INQUIRY INTO IMPACT OF THE ROZELLE INTERCHANGE

Submission to Rozelle Interchange Inquiry

Rozelle Interchange - Active Transport Safety Issues

Issue 6: Path bumps

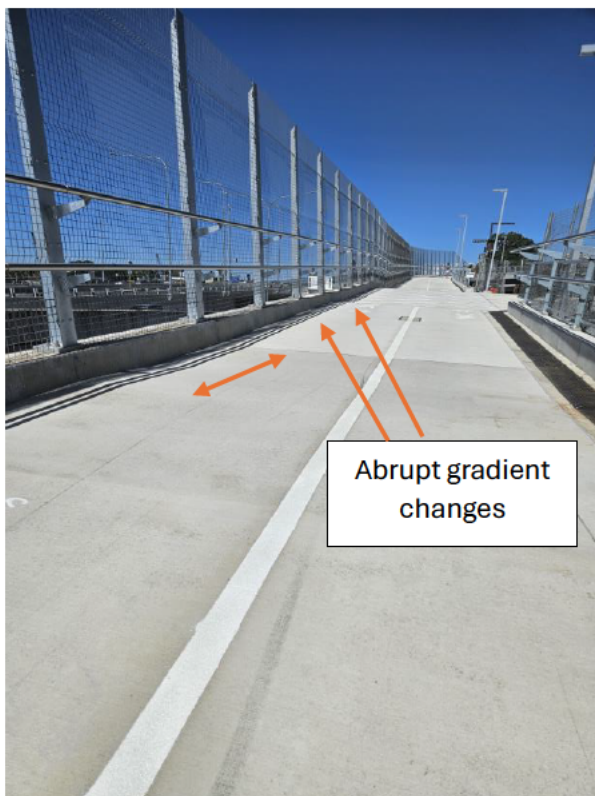
Location: Anzac Bridge Shared Path, Western approach.

The bumps in the path, implemented through rapid changes in pavement gradient, appear to provide no particular purpose. They are dangerous in that an unsuspecting cyclist could lose control. In particular, heading west down the Anzac Bridge off ramp and signalling a right hand turn to the underpass means that a cyclist hits the bumps when they have one hand off the handle bars. This is path “design feature” that cyclists are unfamiliar with – I am not aware of it being used elsewhere. Further, they are impossible to see and there are no markings.

The WestConnex Urban Design and Landscape Plan (“UDLP”) Pedestrian and cycle implementation strategy, section 11.5, point 6, p11-3, required adherence to Cycling Aspects of Austroads Guides. The Austroads Guide to Road Design Part 6A: Paths for Walking and Cycling, section 3.1 General -

- provide surfaces that provide good surface grip, are free of tripping hazards, smooth, clear of obstructions and are well maintained”

Please remove the dangerous bumps in the path and re-lay with a smooth surface.
